CALIBRATION BLOCKS
FOR
INSERVICE EXAMINATION

INDIAN POINT UNIT NO.3 NUCLEAR POWER PLANT
P.O.BOX 215
BUCHANAN,NEW YORK 10511

NEW YORK POWER AUTHORITY
123 MAIN STREET
WHITE PLAINS,NEW YORK 10601

WESTINGHOUSE ELECTRIC CORPORATION
NUCLEAR SERVICE INTEGRATION DIVISION
INSPECTION SERVICES
P.O.BOX 355
PITTSBURGH,PANNSYLVANIA 15230

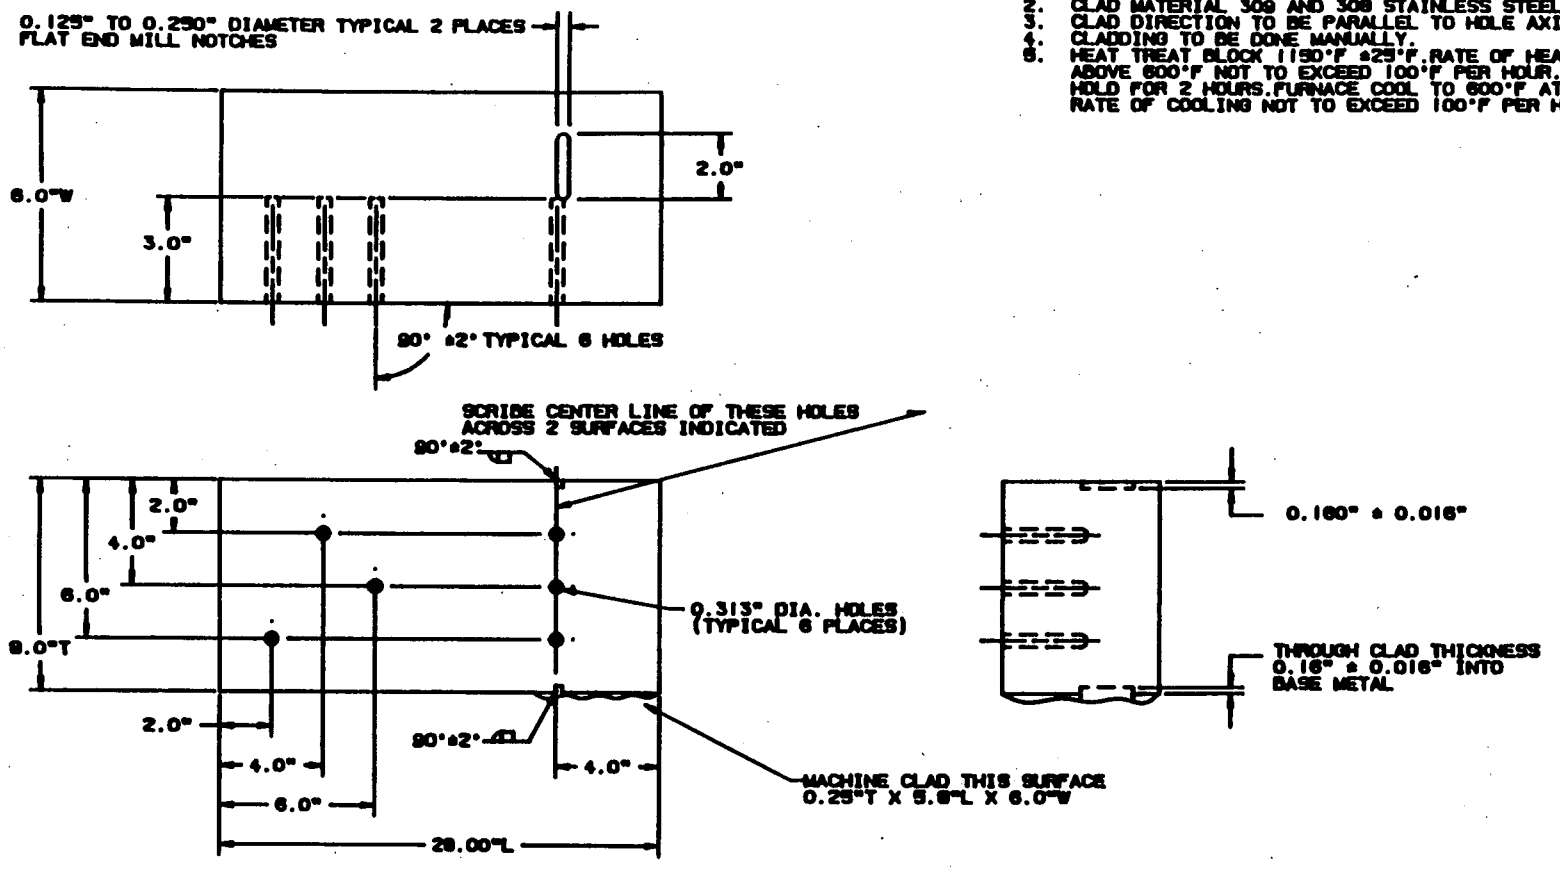
Calibration block to meet requirements of Section V and Section XI - 1983 Edition through Summer 1983 Addenda would require material of A508-64 Carbon Steel or SA302 Grade B Carbon Steel (although P-Number groupings are equivalent with SA533 Class 1 Grade B Carbon Steel), and as required by Figure T-434 cladding to be 100% of width and length, and hole tolerances documented.

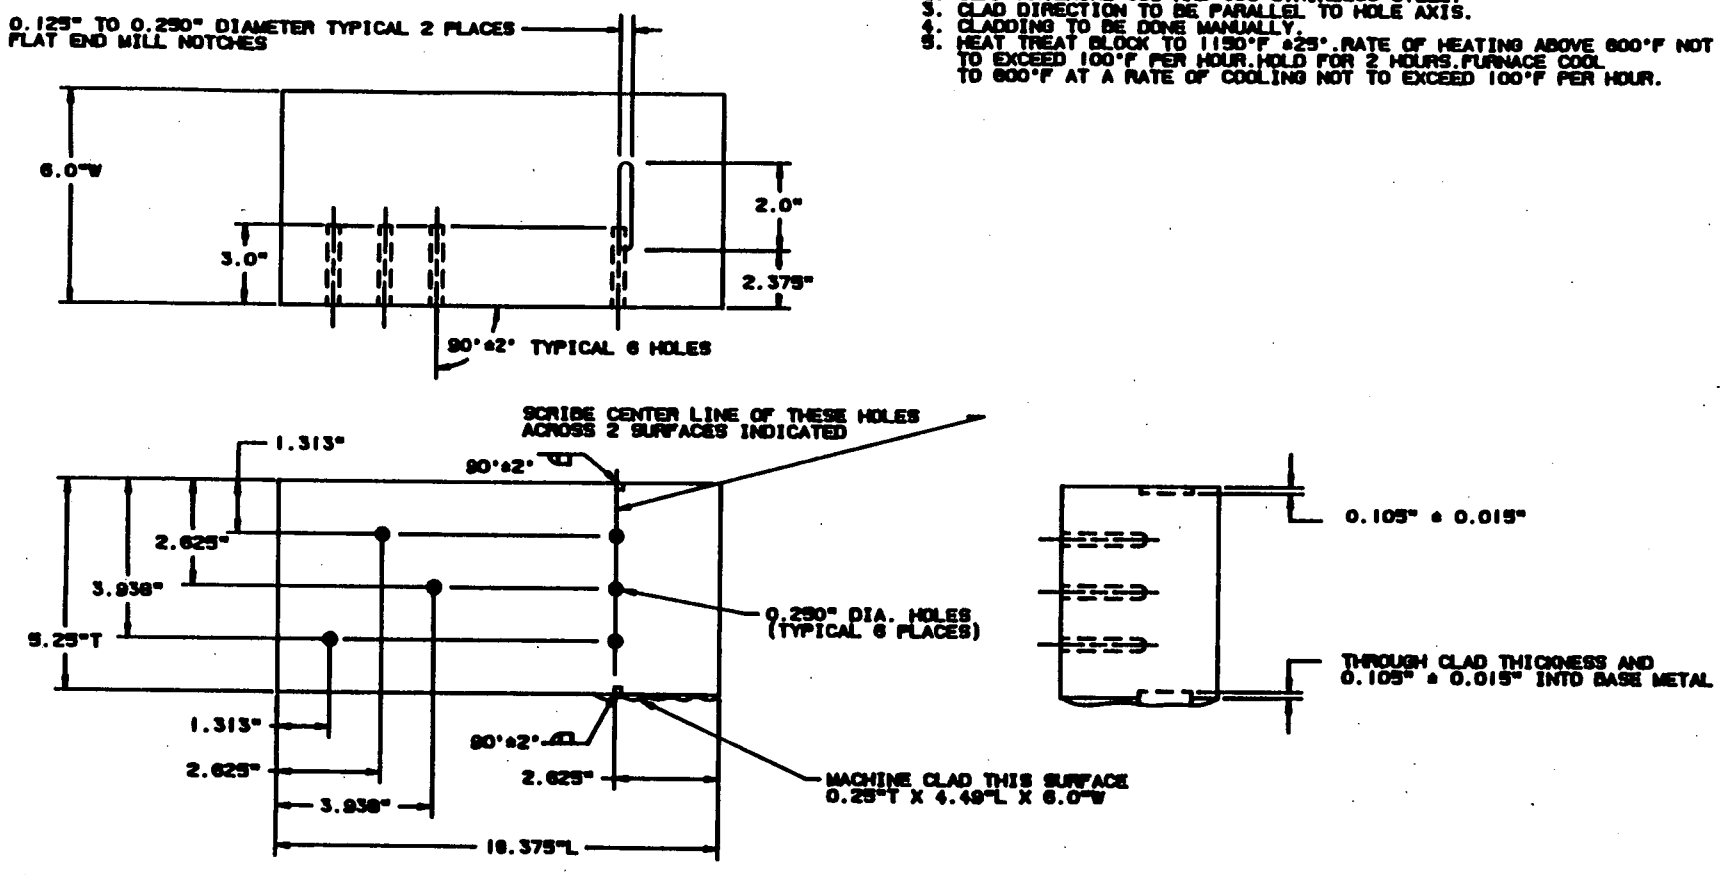
Calibration block to meet requirements of Section V and Section XI - 1983 Edition through Summer 1983 Addenda would require material of SA216 Grade WCB Carbon Steel (although P-Number grouping is equivalent with SA508 Class 2 Carbon Steel), and as required by Figure T-434 side drilled hole to be located 1.5" minimum from edge instead of 1.313", cladding to be 100% of width and length, and hole tolerances documented.

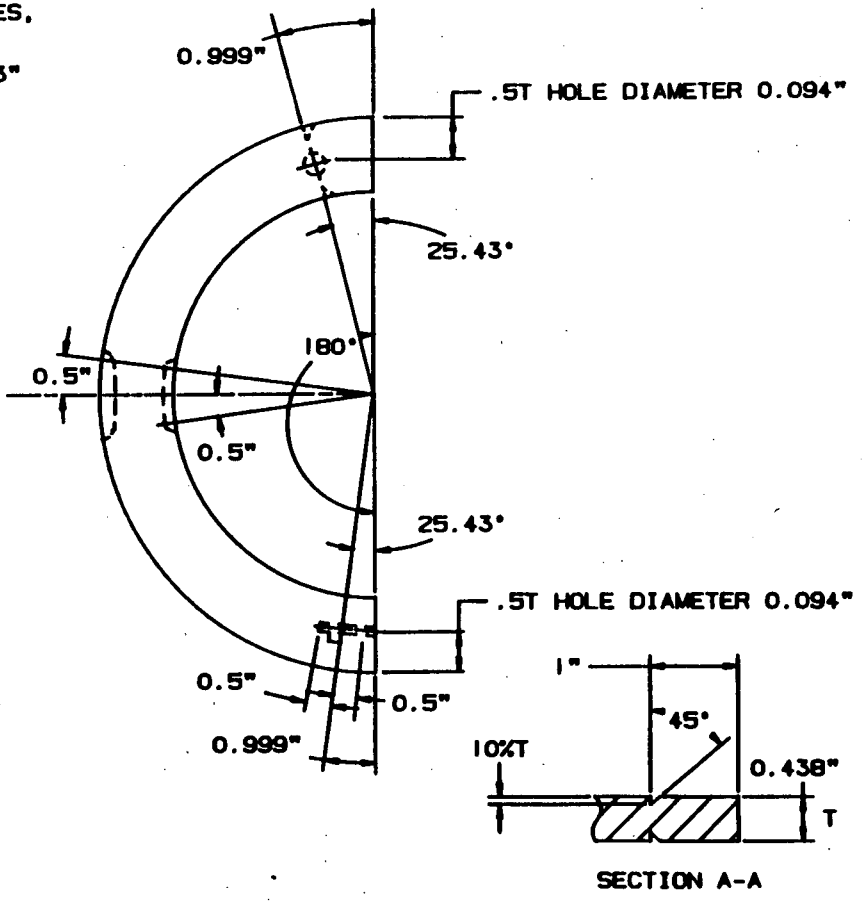
Calibration block design follows the guidelines of Section V and Section XI - 1983 Edition through Summer 1983 Addenda for Austenitic Piping. Modifications of this design to meet the requirements of Section V and XI-1983 Edition through Summer 1983 Addenda for calibration blocks for "Ferritic Piping and Design T-547.1" would be to increase length to 8" and arc length to 270° and as required by Table III-3430-1 notch depth to 0.104T - 0.009T squared with tolerance of +10% - 20%.

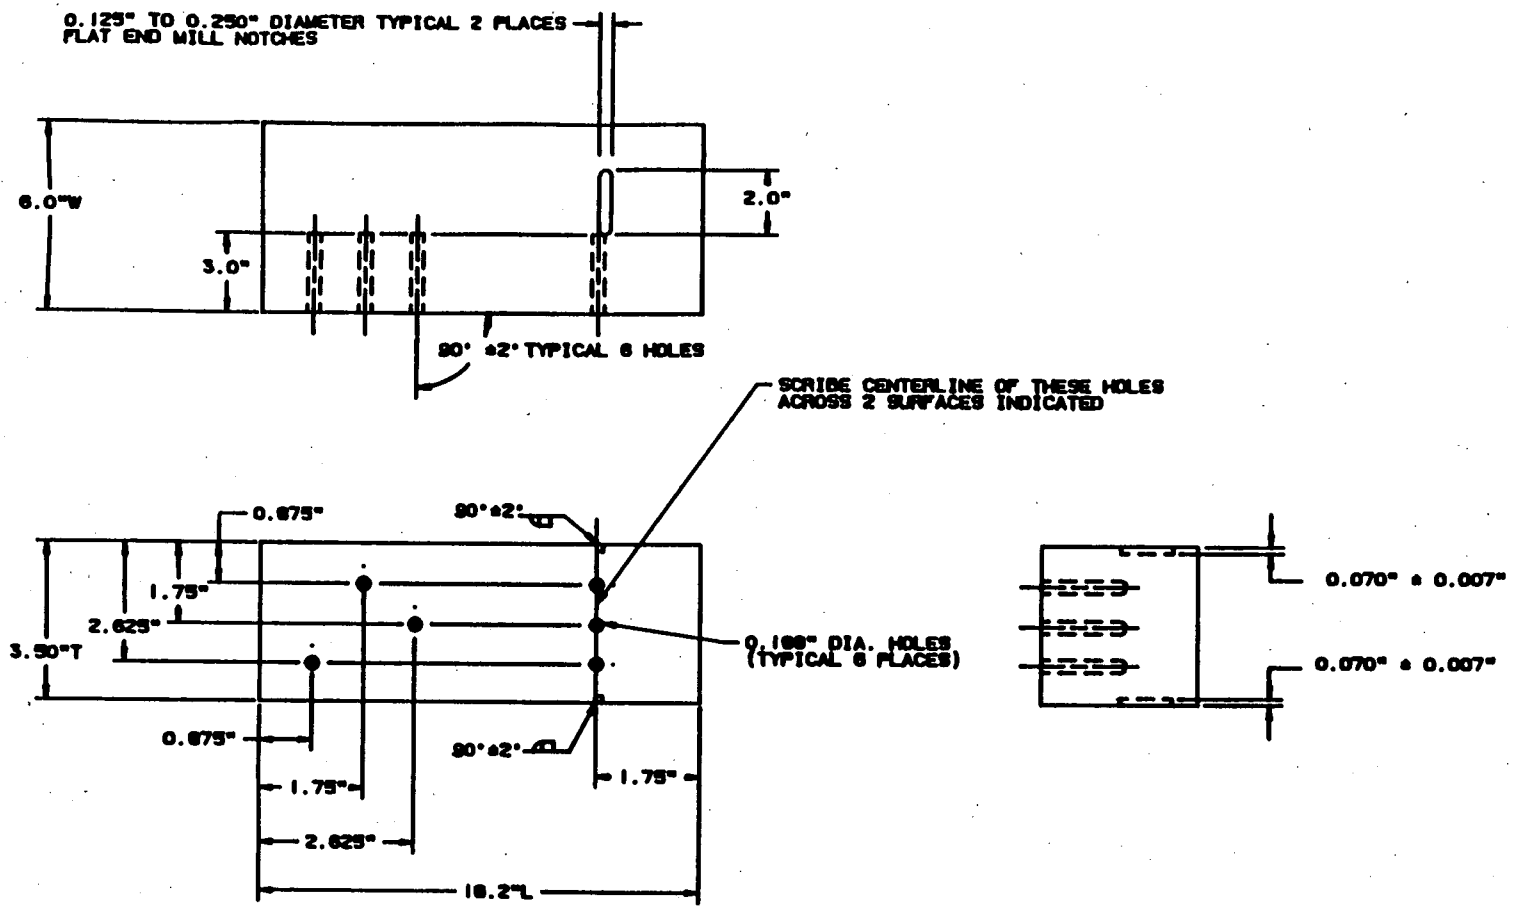
Calibration block to meet requirements of Section V and Section XI - 1983 Edition through Summer 1983 Addenda would require material of SA302 Grade B Carbon Steel (although P-Number grouping is equivalent with SA533 Class 1 Grade B Carbon Steel), and as required by Figure T-434 side drilled hole to be 1.5" minimum from edge instead of 0.875", and hole tolerances documented.
